# HDC

## ADMINISTRATIVE APPROVALS

June 09, 2021

HDC Land Use Compliance Report  
232 Court Street  
Portsmouth, NH 03801

February 7, 2020 Historic District Commission Approval – Sheet A2.01: Exterior Elevations (Dormers)

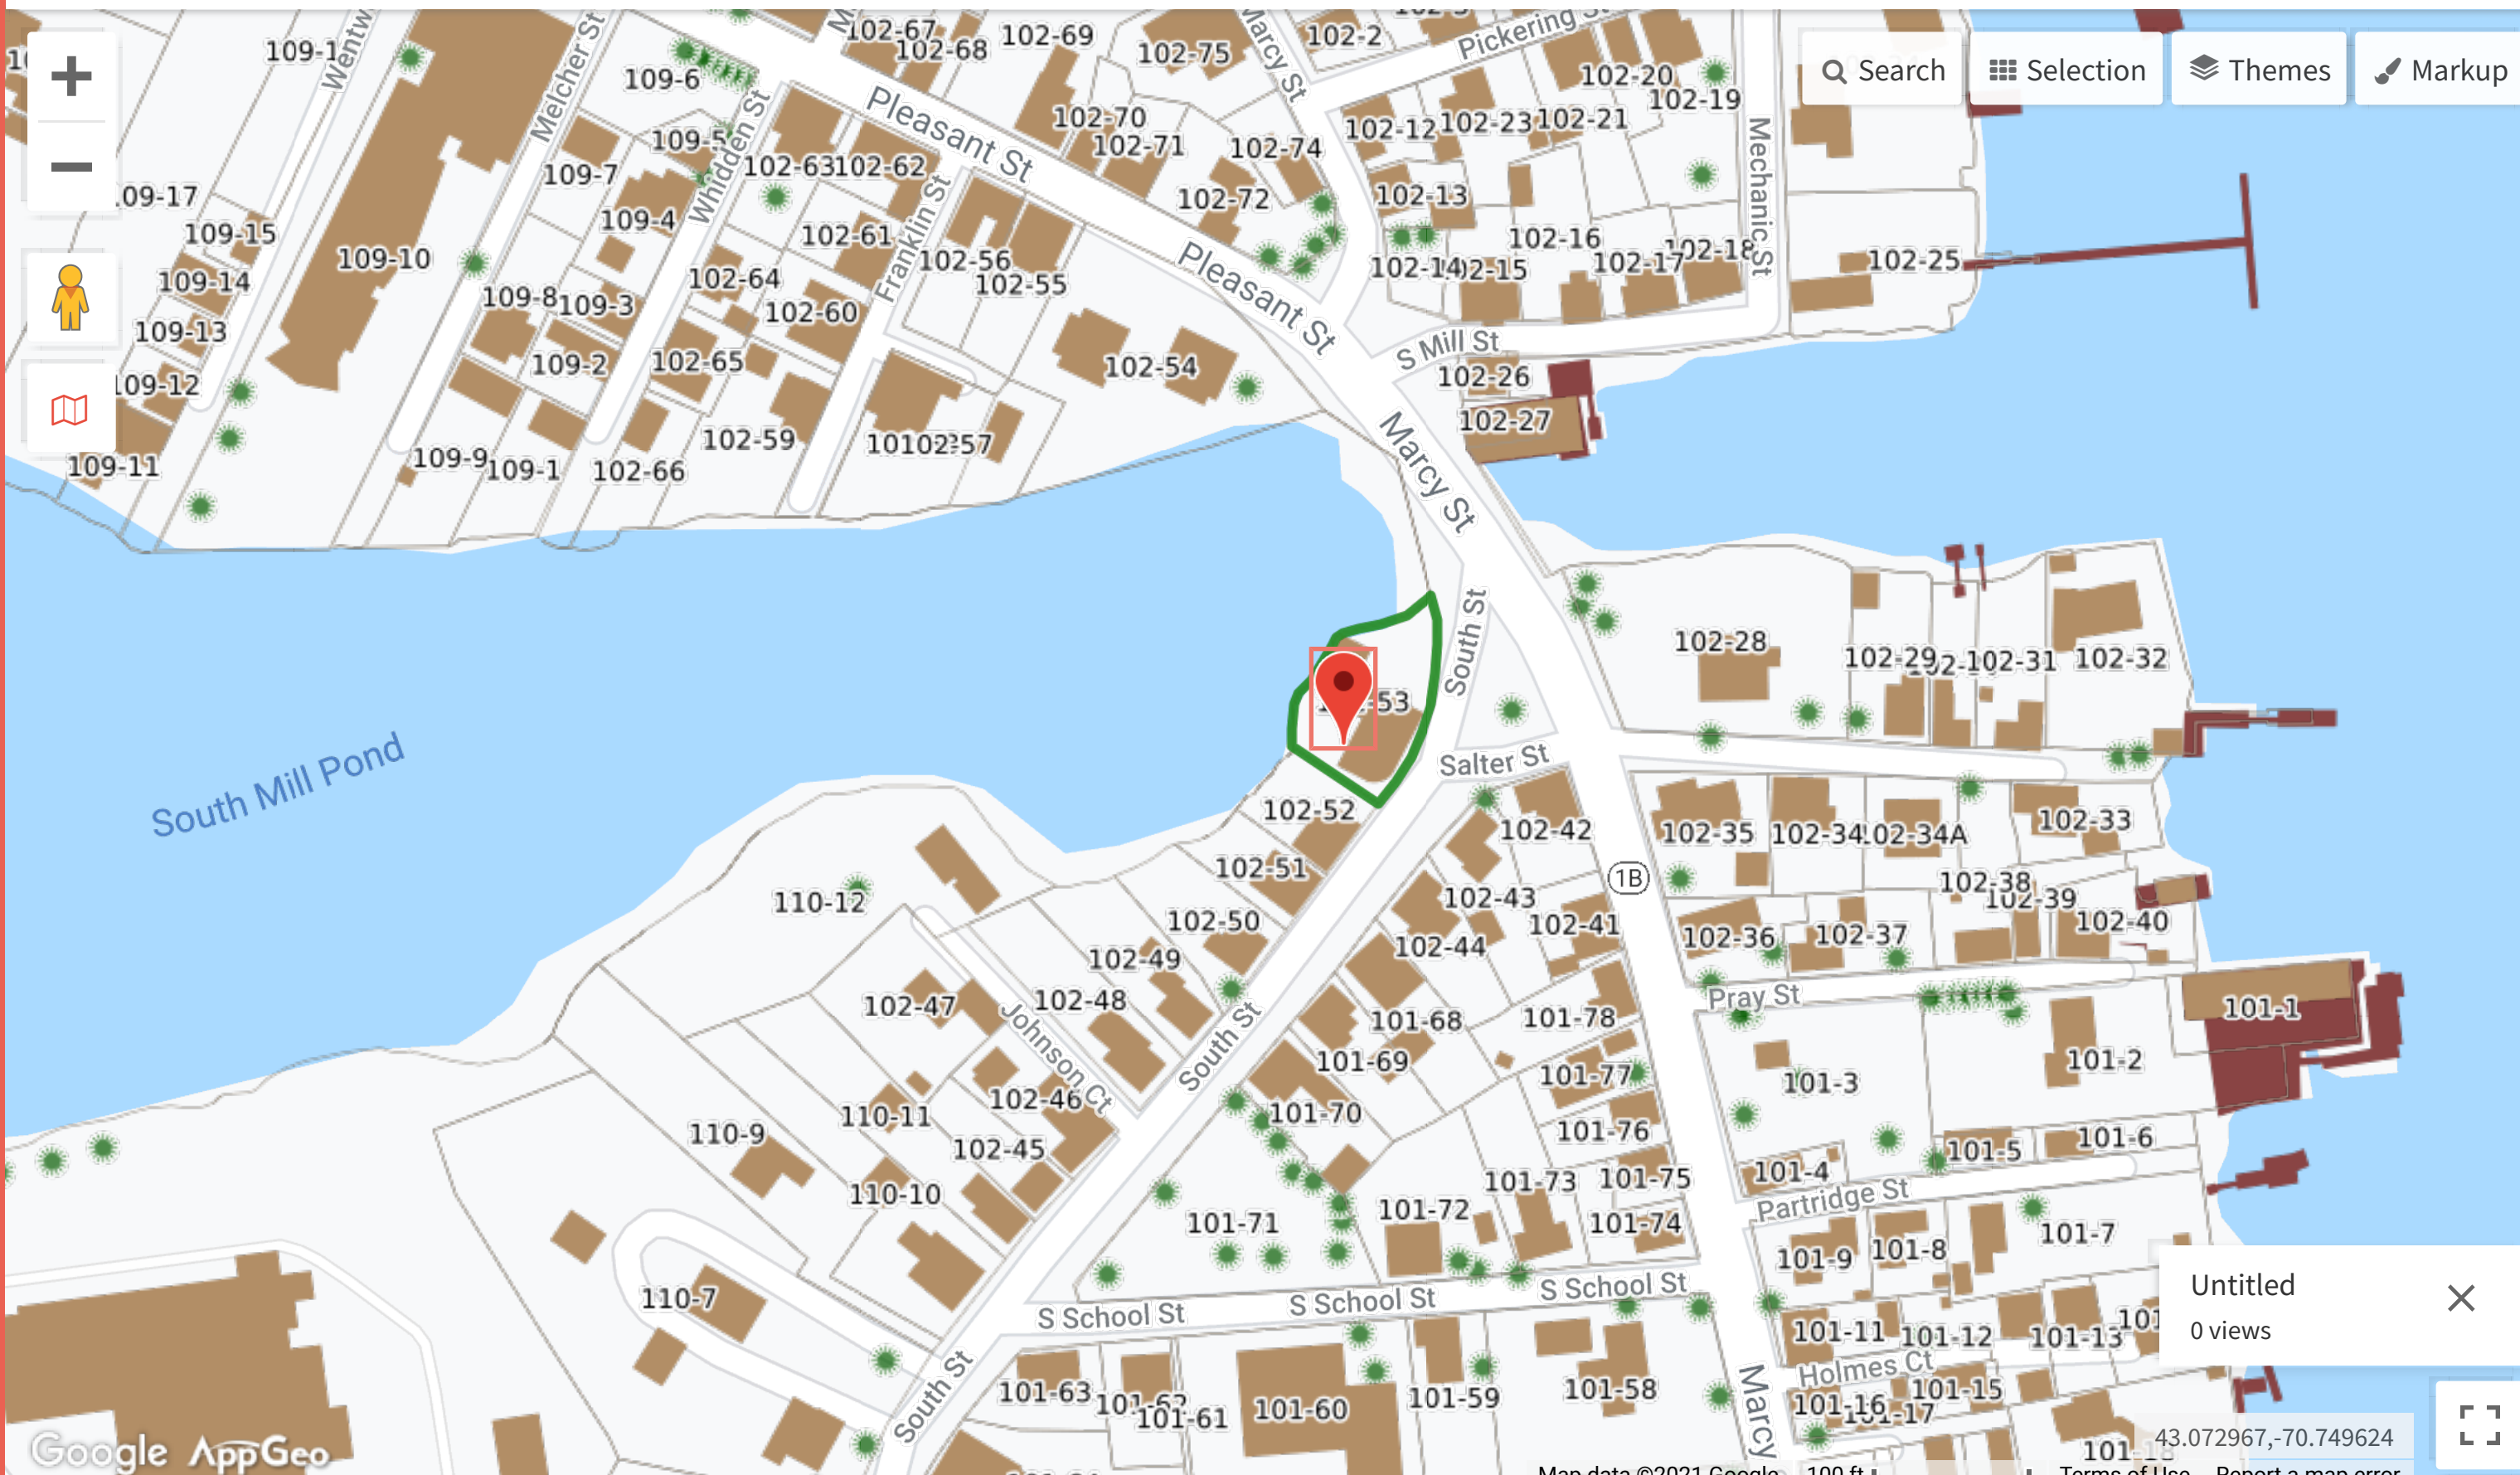
Alterations to the Approved Design:

- A. 6/6 window replaced with 8/8 window.

B. Open wooden deck omitted.

Alterations to the Approved Design:

- C. Stud pockets are wider than window casing.
- D. Clapboards added to either side of window casing (i.e. on right dormer).
- E. The dormers are located lower on the roof slope (i.e. aligning more with the wall plane beneath).
- F. The dormers have increased in height (e.g. clapboards added under window sills).
- G. The dormers have been widened (e.g. overhangs omitted).
- H. 3/3 windows replaced with 6/6 windows.

**Please Note:** Stipulation 1 of the February 7, 2020 Historic District Commission Approval calls for, “Only window casing shall be added to the face of dormers.”

A KITCHEN DESIGNED CALLED FOR WIDER UNIT WHICH TRIGGERED THE GRID PATTERN CHANGE ACCORDING TO WINDOW REP

B DECK WAS NOT INTENDED TO BE REPLACED AFTER THE DEMOLITION - GRADING

C FRAMERS DECISION ON SITE

D NEEDED WIDTH ON DORMER TO (ALLOW) GIVE THE SPACE NECESSARY FOR STAIRS AND HALLWAY THE CLIPBOARD (SEE PICTURE) DRESSED UP THAT AREA

E TO CREATE A LANDING AT TOP OF STAIRS (STAIRS)

F HEIGHT WAS NEEDED FOR PERSON TO BE ABLE TO STAND ONCE ON THE LANDING (SEE PIC)

G NEEDED WIDTH ON DORMER TO ACCOMMODATE STAIRS / HALLWAY NEEDED TO ACCESS LIVING SPACE

H BROSCO WINDOWS WERE APPROVED ON 7/16/20 AT ON ON SITE MEETING WITH NICK, DAN RAWLING LUKA CELEBEC (THE WINDOW RESTORER) AND GARY BEAULIE (BROSCO WE ALL AGREED CLOSELY RESEMBLED OUR RESTORED WINDOW

I YES, ORIGINALLY 2 CLOSEST TO STREET WERE TO BE RESTORED WINDOW AND 3 3RD UNIT WE RAN ONE WINDOW SHORT SO IT WAS ADDED TO THE NEW WINDOW UNIT WAS NOT ADDED IT WAS ALWAYS THERE

J SEE "H" TO KEEP THE STREETSIDE APPEARANCE CONSISTENT

K NOTE WE INTENDED USE ALL BROSCO FR THAT CONSISTENT LOOK BUT THEY SOLD THE BUSINESS RIGHT AS WE WERE APPROVED SO WE NEED TO FILL THE REMAINING OPENING WITH GREEN MTU

1. Change the two people-doors in garage (blue ovals):

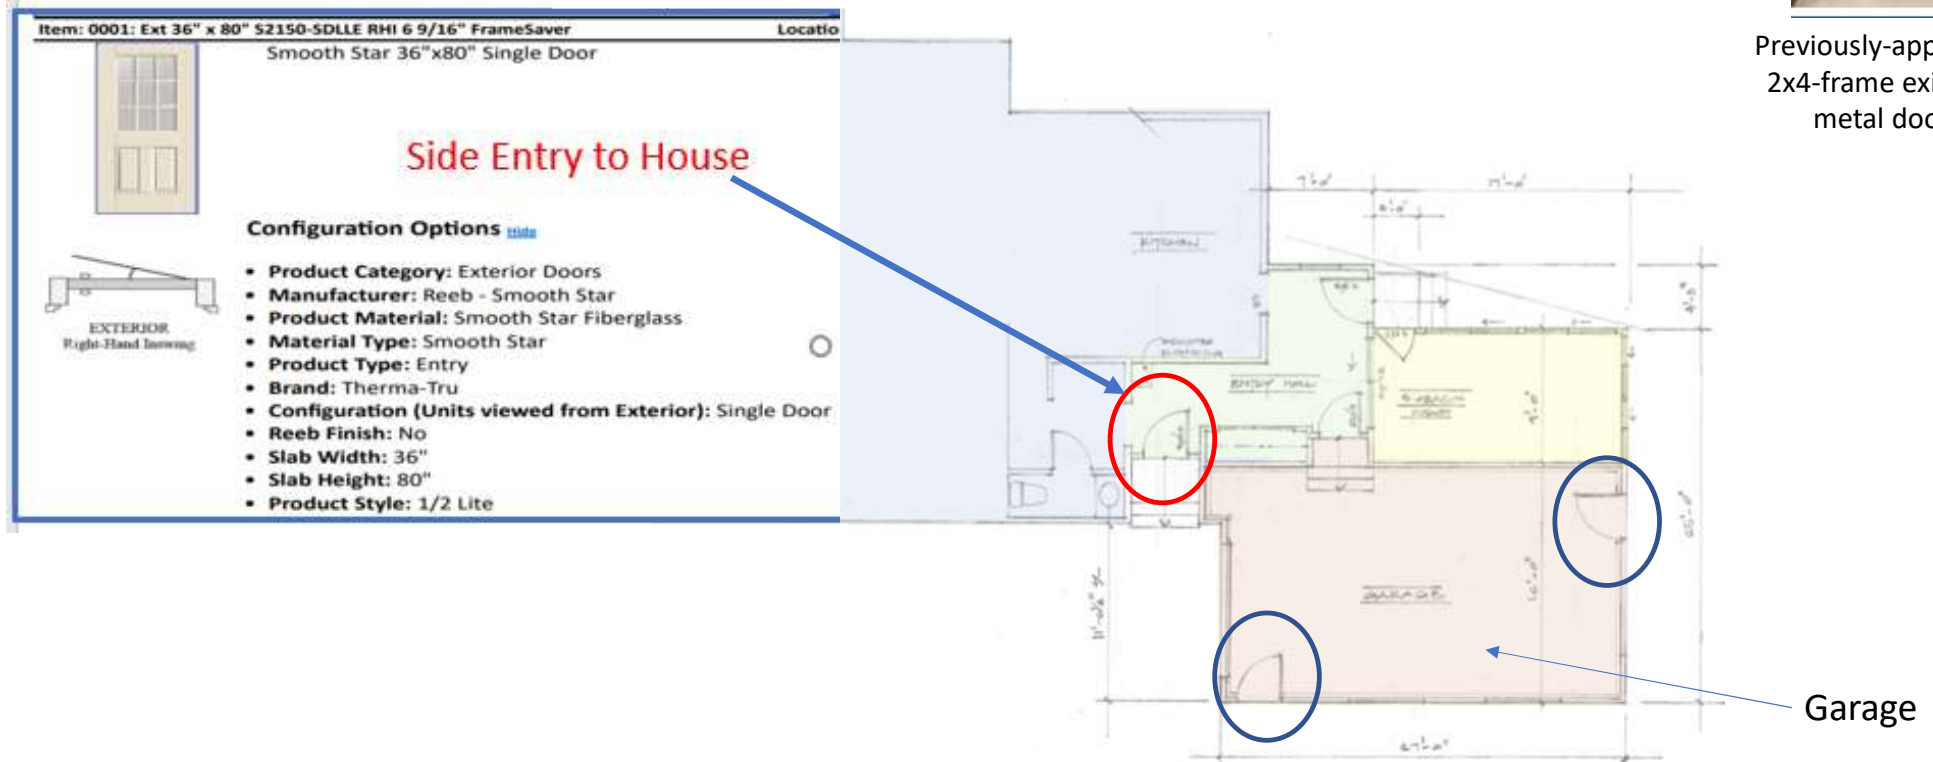
We learned after approval that the existing metal doors are built on 2x4 frames, while the garage is 2x6, so we cannot use these doors for the garage.

Solution - Install the same door as approved for the Entry:

Therma-Tru Smooth Star, smooth surface (no wood grain texture), field-painted fiberglass (red oval)

Proposed Side Elevation –  
5 windows, no porch door

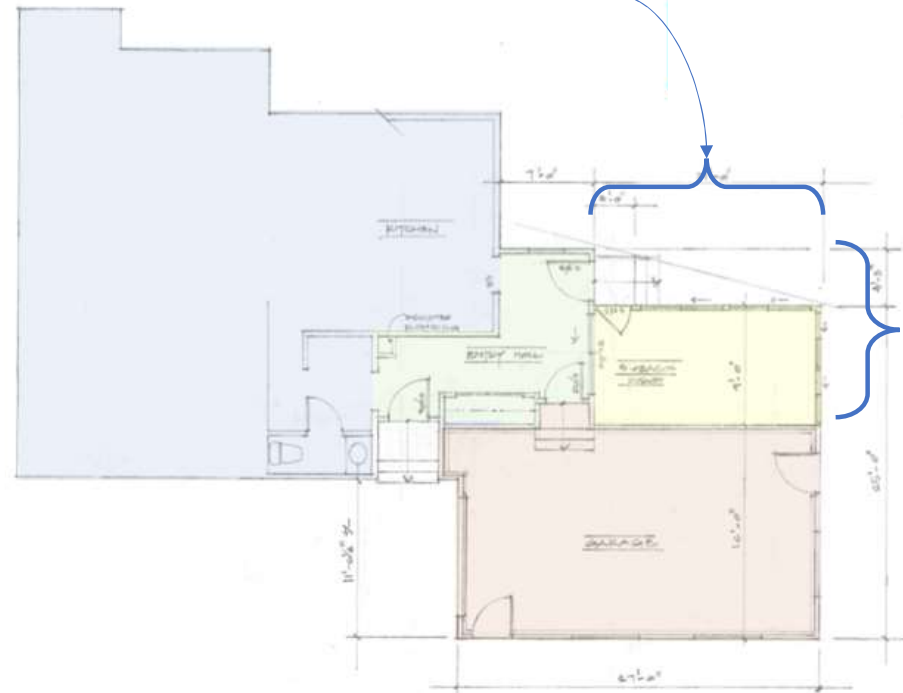
## 2. and 3. Porch windows.

Replace porch door to outside landing with a window

Replace approved vinyl slider windows with double-hungs (approx. 36x72).

Wood/fiberglass, half-screen, simulated divided lites (int, ext, and between glass)

Preferred Option: Marvin Elevate (was Marvin Integrity)

Preferred Option: 2/1 (shown)
